**TOWN OF COVENTRY, RI
DEPARTMENT OF PLANNING & DEVELOPMENT**

STAFF REPORT

Project Name:	Torborg ADU
Plan Type:	Unified Development Review (Accessory Dwelling Unit w/ associated Dimensional Variance)
Owner/Applicant:	Vincent & Alicia Torborg
Address:	100 Reservoir Road
Plat / Lot / Zone:	AP 43 Lot 18 Zone R-20 Lot Size 0.97 acres
Existing Use:	Single-Family Dwelling
Proposed Use:	Single-Family Dwelling with an Accessory Dwelling Unit (ADU)
Description:	The applicants propose to construct a 2,600 SF two-bedroom Accessory Dwelling Unit (ADU) on their 0.97-acre parcel. The applicants seek one Dimensional Variance as the ADU will exceed the maximum unit size requirements.

TECHNICAL REVIEW COMMITTEE REPORT

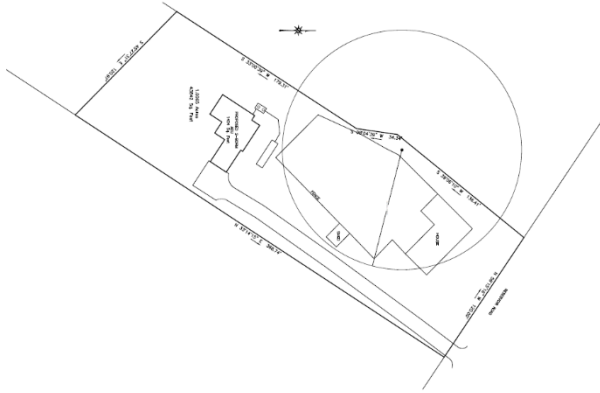
The applicants propose to construct a 2,600 SF two-bedroom ADU, which will include 995 SF of interior living space, a 352 SF single-car garage, a 180 SF wooden exterior deck, a 78 SF covered porch, and a 995 SF unfinished basement. It will be occupied by the applicants' daughter. This ADU will be sited in the rear yard, behind the chain-link fence that surrounds the grass lawn, and will be served by a proposed driveway of 200' in length with a separate curb cut on Reservoir Road. A new on-site wastewater treatment system (OWTS) will also be installed. The applicants have submitted a landscape plan that shows trees to be removed and preserved.

4. Planning staff recommends that the applicant reduce the size of the ADU, specifically through the removal of the proposed deck and covered porch from the site design. With these removed, the total floor area of the ADU would decrease to 2,342 SF.

7. Planning staff recommends that the applicant adjust the proposed driveway to retain the existing oak tree and rhododendron in the front yard and ensure visual screening.

8. The applicant shall preserve all existing trees within 75' of the rear property line.
9. Planning staff notes that the orientation of the garage entrance shown on the site plan appears to disagree with the orientation of the garage entrance on the floor plan.

1. The accessory structure’s construction is conditioned upon strict adherence to the associated Dimensional Variance Application as presented and approved.
2. The applicant shall reduce the size of the ADU through the removal of the proposed deck and covered porch from the site design.*
3. The applicant shall fill in the small gap in the existing row of arborvitaes along the northeastern property line that will be adjacent to the proposed driveway, to ensure adequate visual screening for abutting house.
4. The applicant shall preserve all existing trees within 75’ of the rear property line.
